Application for Variation of an Environmental Permit

Proposed Golf Course Development at Tai Po Lot No. 246 Shuen Wan

Environmental Review Report for Application of Variation of Environmental Permit (VEP)

Reference: 289499-REP-013-06

Attenuation Ponds Location

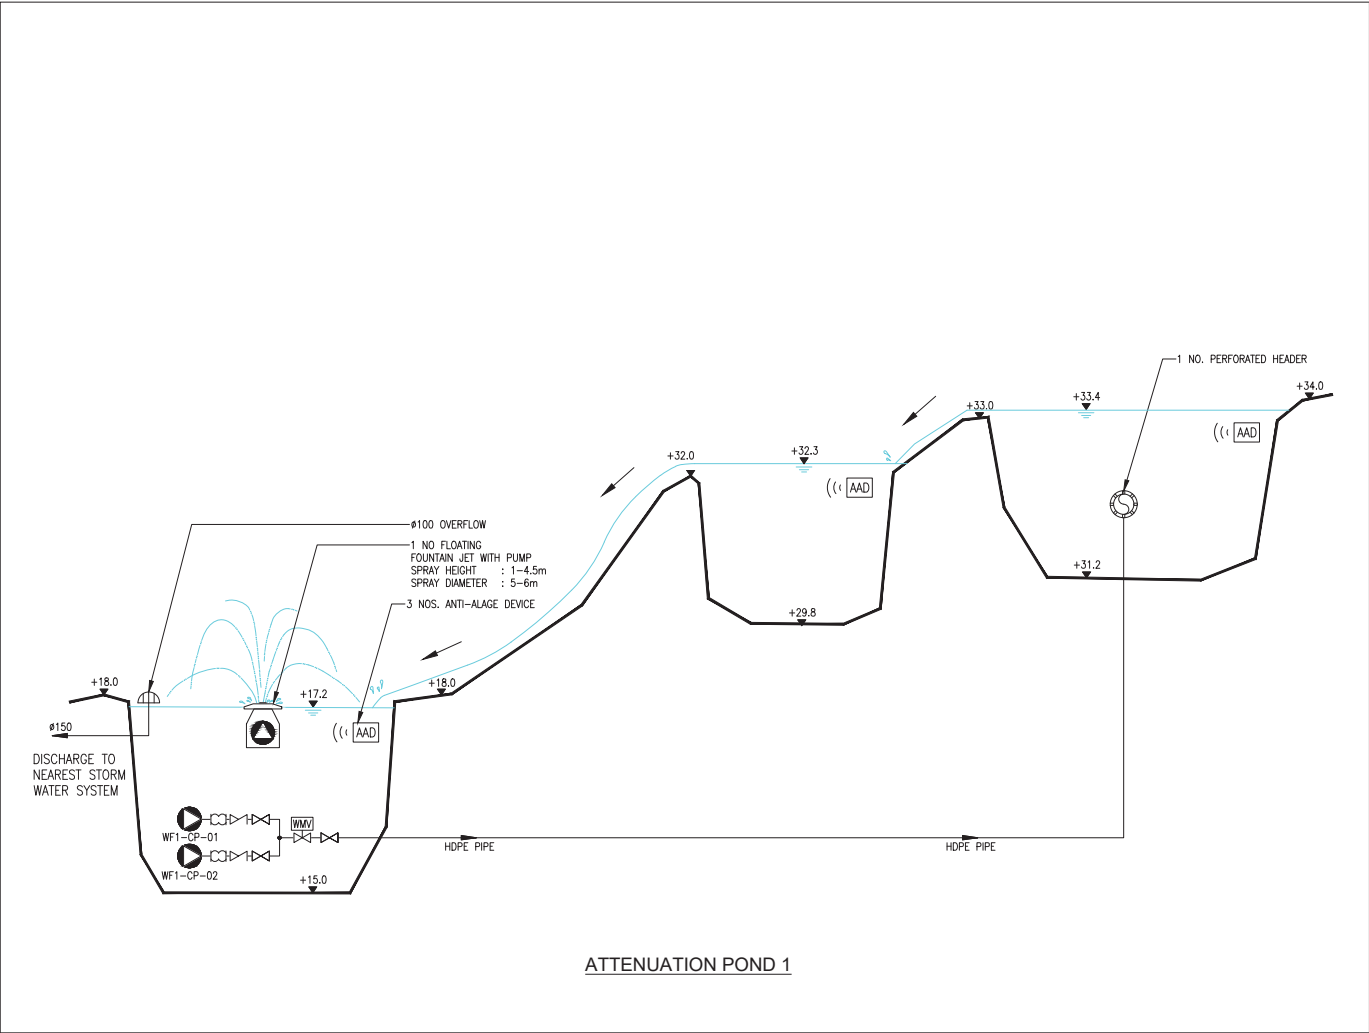
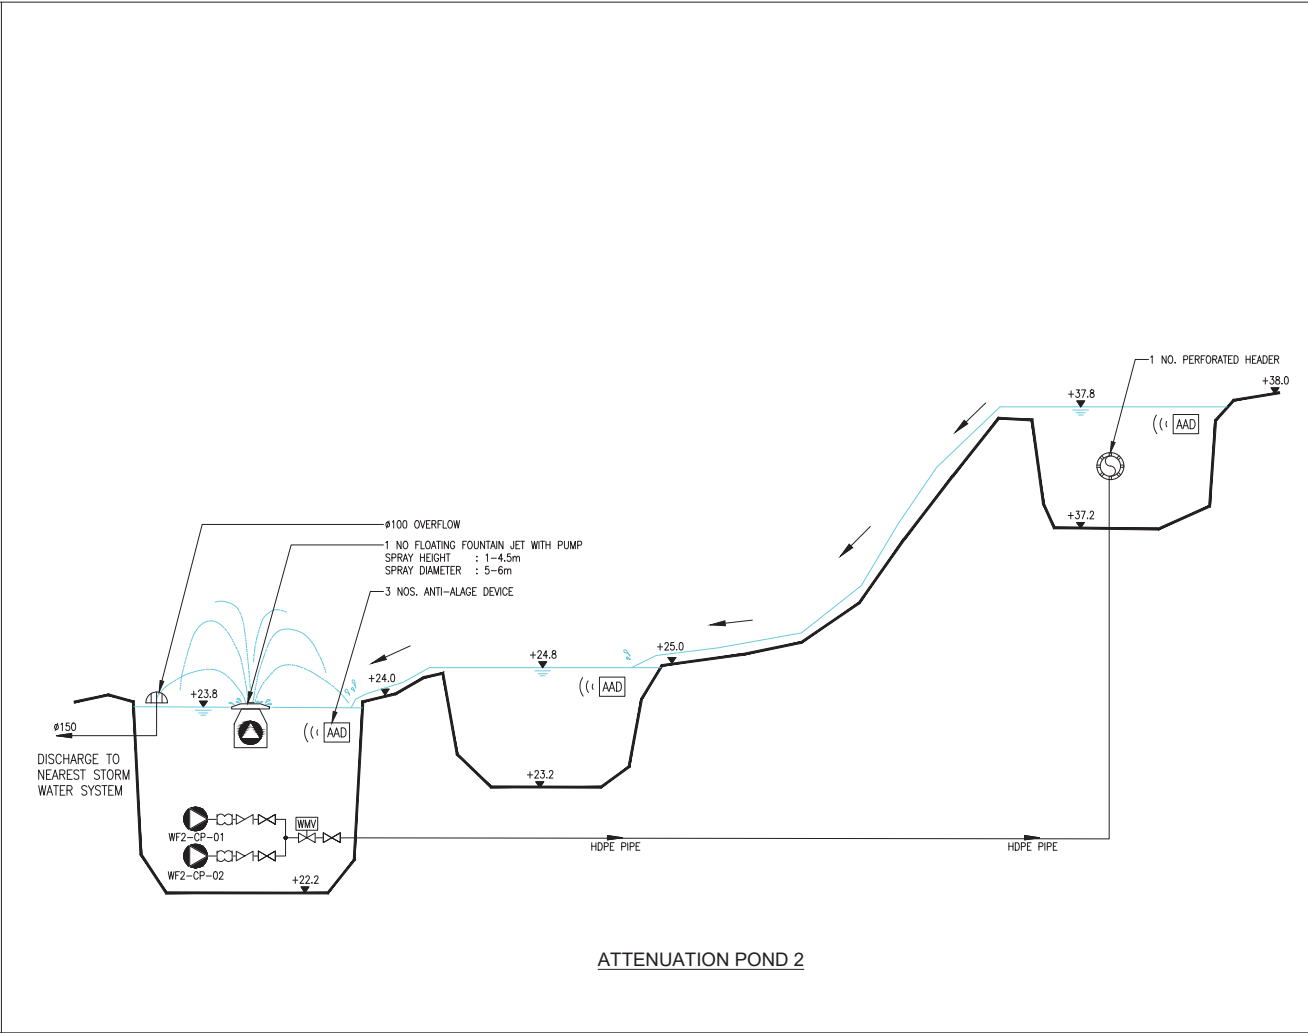
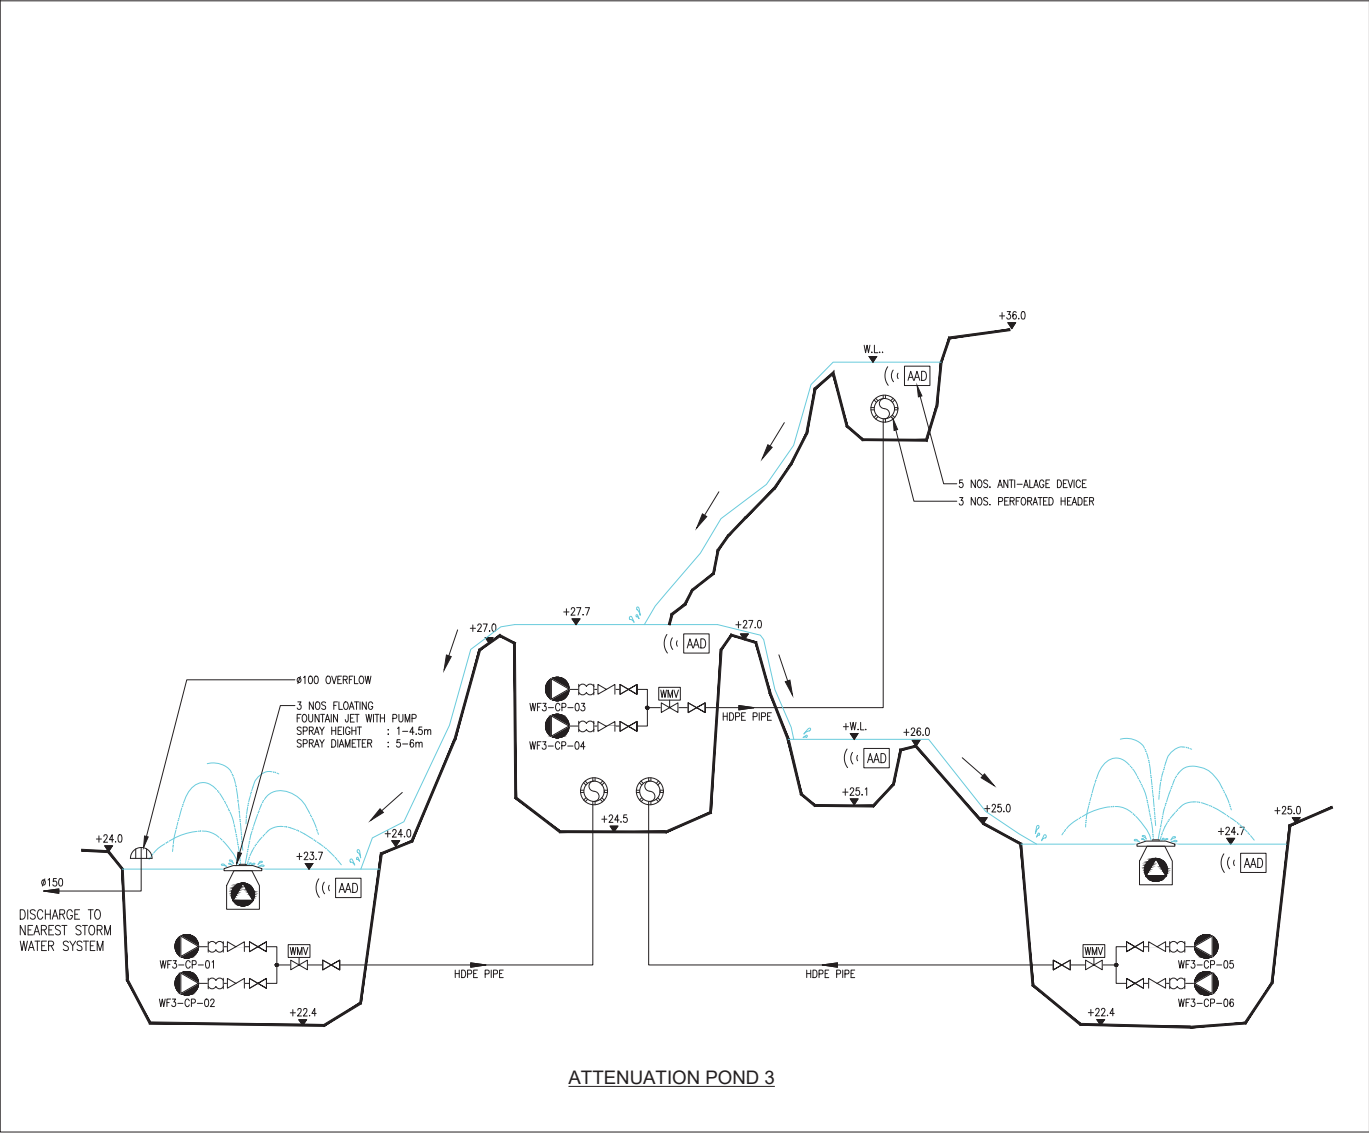
- 3.1.1.4 In the latest stormwater drainage design presented in **Appendix 3.1**, water storage system(s) is proposed with water storage tanks with a capacity of 15,000 m³ (i.e. comprising 8,000 m³ at the Practice Range and 7,000 m³ at the Clubhouse) supplemented with three attenuation ponds with a combined capacity of approximately 4,800m³, forming

a total capacity of about 19,800 m³. Under the latest stormwater drainage design, a summary of water storage plan has been formulated as **Table 3.1** below. The overflow of the attenuation ponds will ultimately connect to the water storage tanks. The proposed water storage system(s) has been optimised to address the Project Site constraints while maximising the capacity of the water storage tanks and attenuation ponds. It is therefore proposed to reduce the total capacity of the water storage system(s) supplemented with attenuation ponds from the original 30,000 m³ to 19,800 m³ as required in Conditions 2.39 and 2.46 of FEP-01/571/2019/A, and to be further reviewed in the Turfgrass Management Plan (TMP) under Condition 2.26 of FEP-01/571/2019/A. The subsequent sections will present the factors considered for the proposed amendments.

Drawing title
PROPOSED LOCATION OF OUTFALL

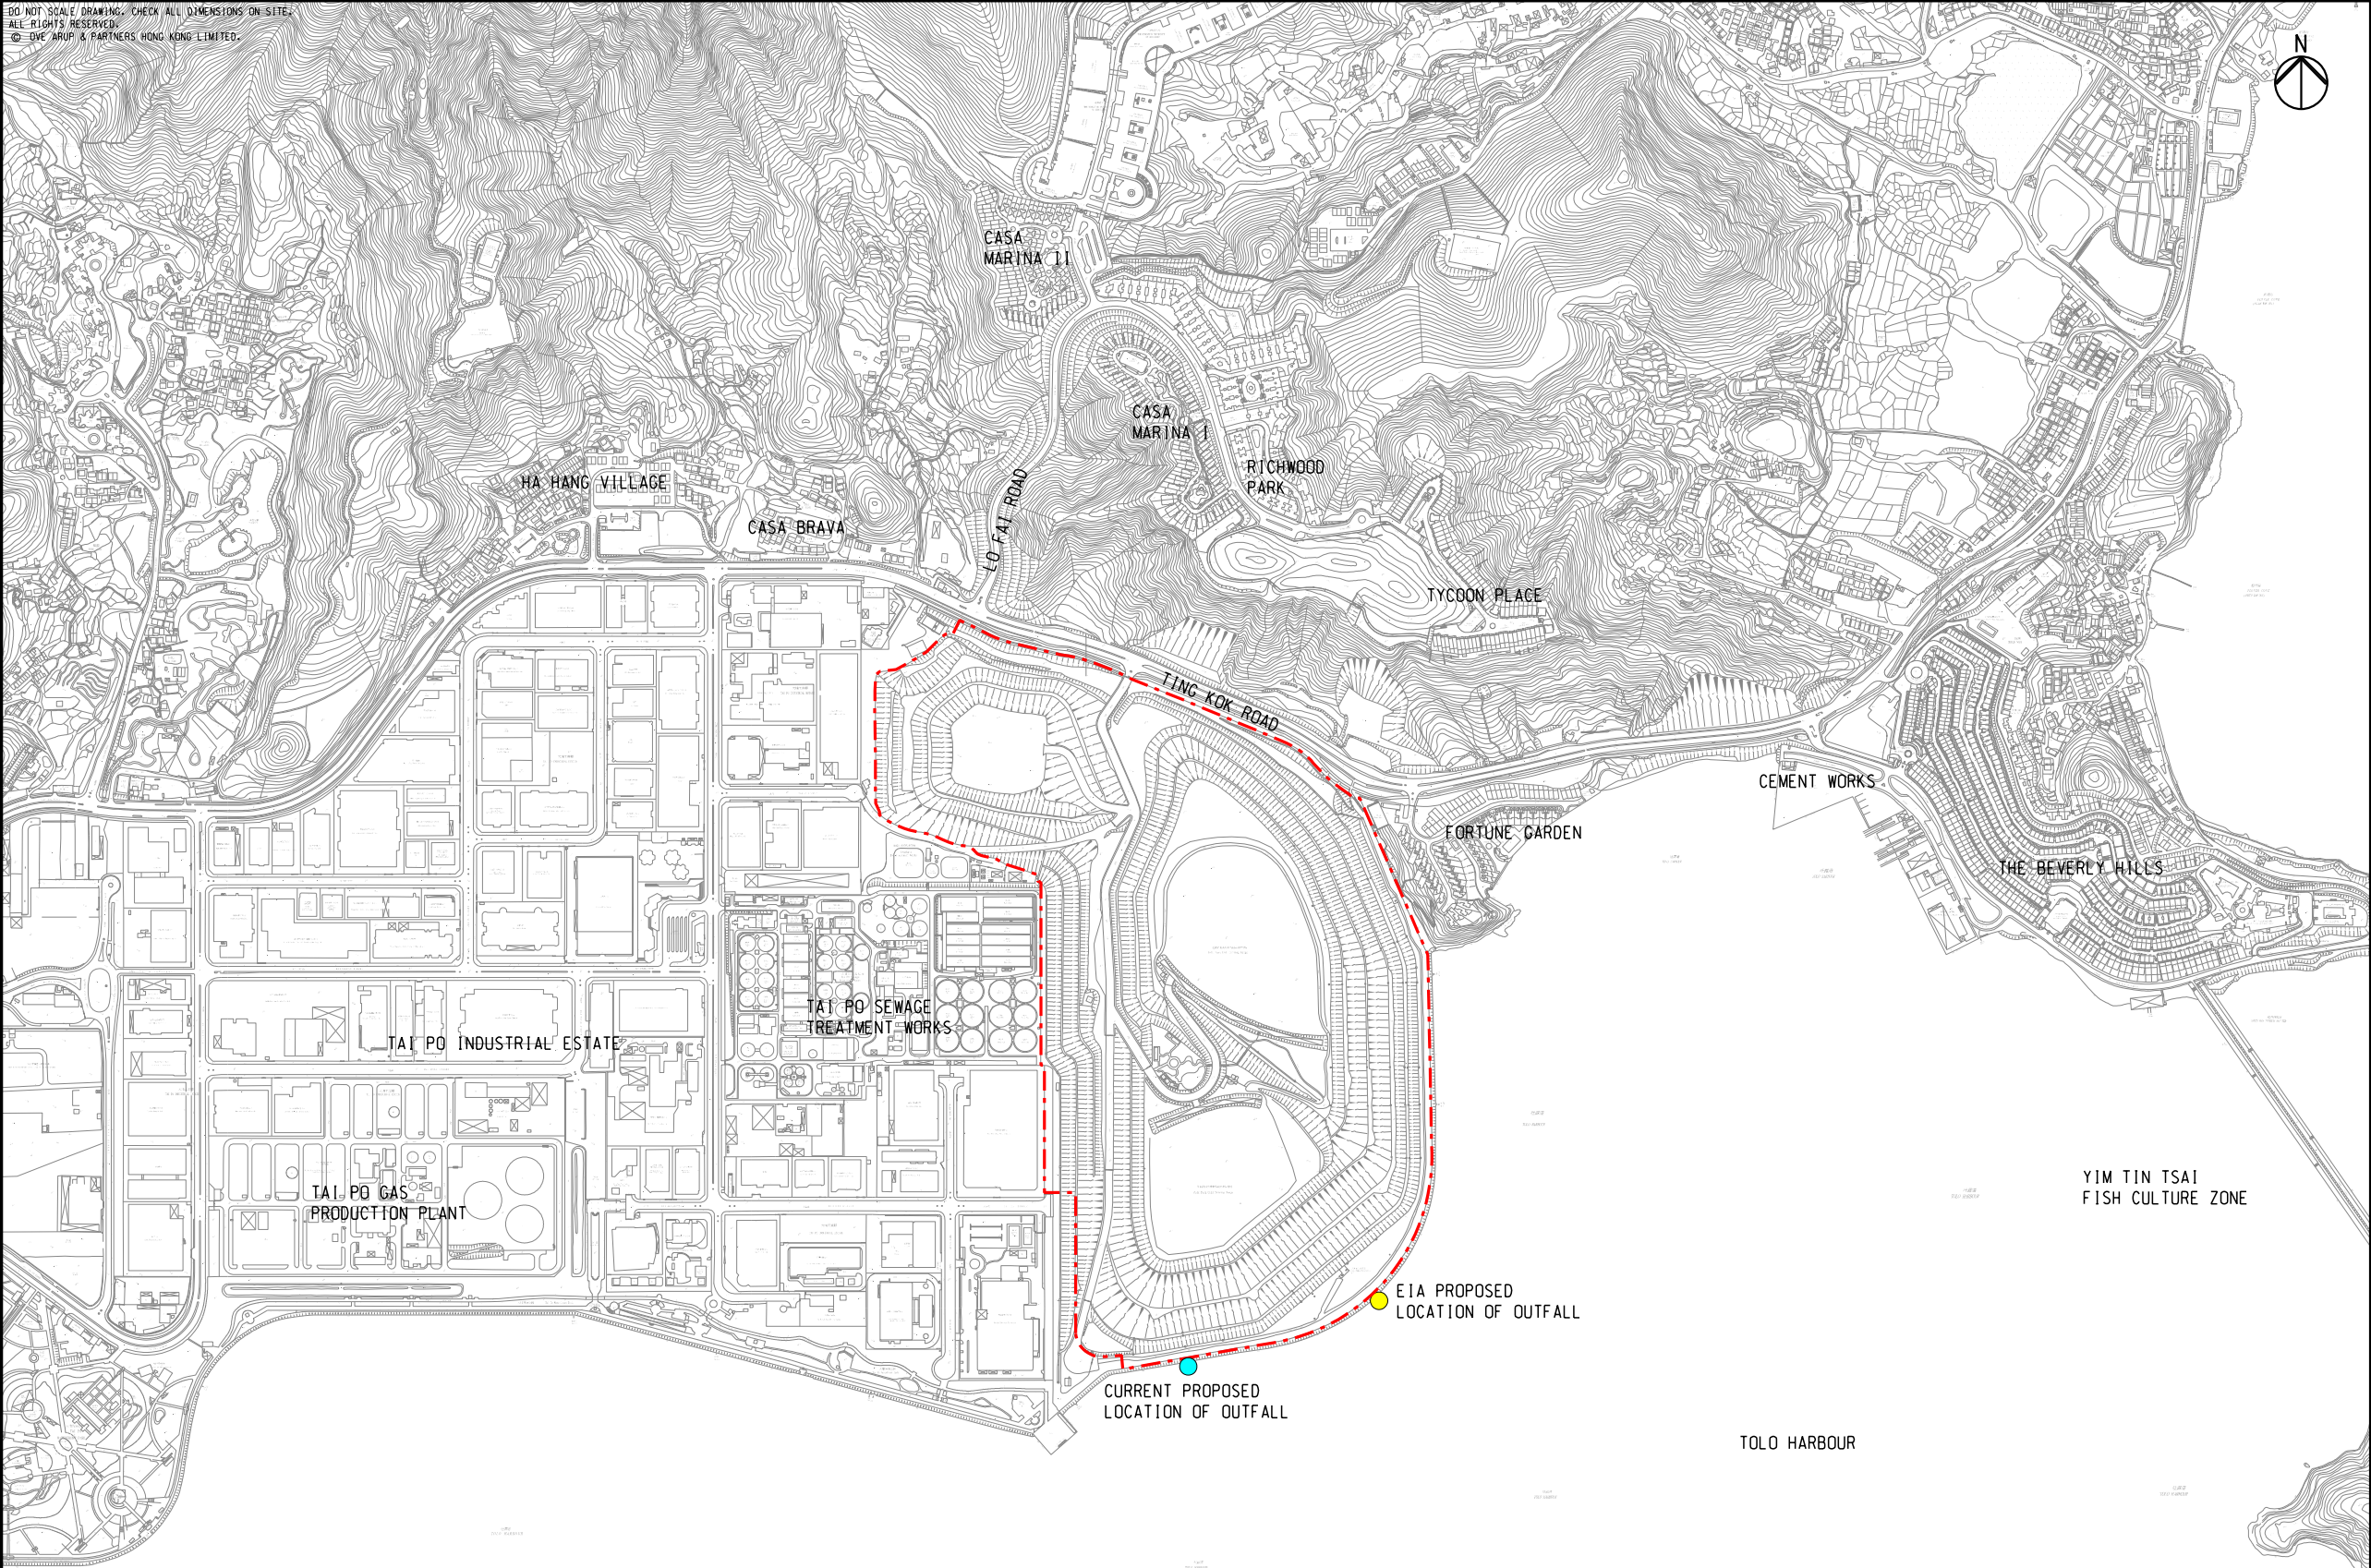
3.6.1.6 As discussed in **Section 3.1**, another existing drainage outfall has been selected as the proposed location of outfall under the current detailed design stage, as shown in **Appendix 3.1**. Compared to the proposed outfall location in the approved EIA Report, the new proposed outfall location is further away from the Yim Tin Tsai Fish Culture Zone but slightly closer to the WSRs, e.g. Water Services Department Seawater Intake in Tai Po and the corals located south of the Project Site, etc. As discussed in **Section 3.5**, with the latest
